Report Type: DA Access Report
Reference Number: 18231
Client: Zhinar Architects
Site Address: 824-834 Forest Road, Peakhurst NSW

ACCESS REPORT

This Access Compliance Report is to accompany a Development Application for the development proposed at 824-834 Forest Road, Peakhurst NSW.

ADAPTABLE UNIT / ADAPTABLE UNIT A09

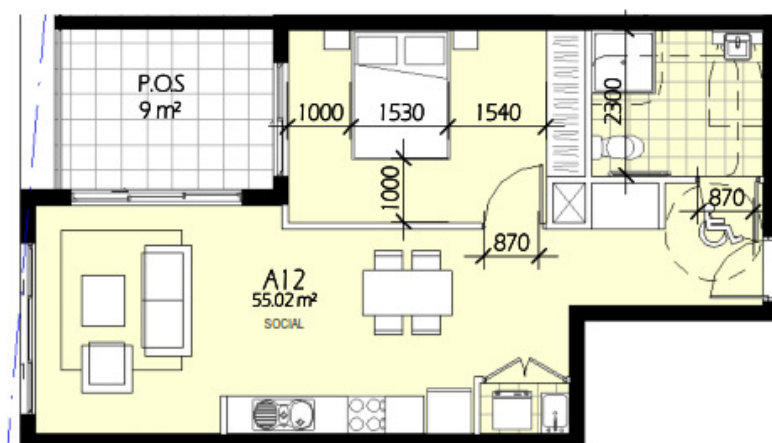
At DA stage there is insufficient information to certify compliance with the Standard, however, in accordance with the table below, the nominated units can comply with the spatial requirements of AS4299 for Adaptable Housing.

SILVER LEVEL UNIT A04

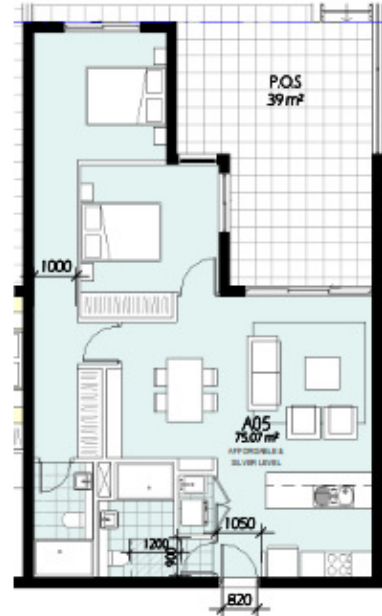
The following 15 units **A02, A04, A05, A06, A14, A15, A16, A17, A18, A20, A24, A25, A26, A27 and A28** are capable of providing compliance with the features of Silver level of Livable Housing Guidelines as noted in the table below.
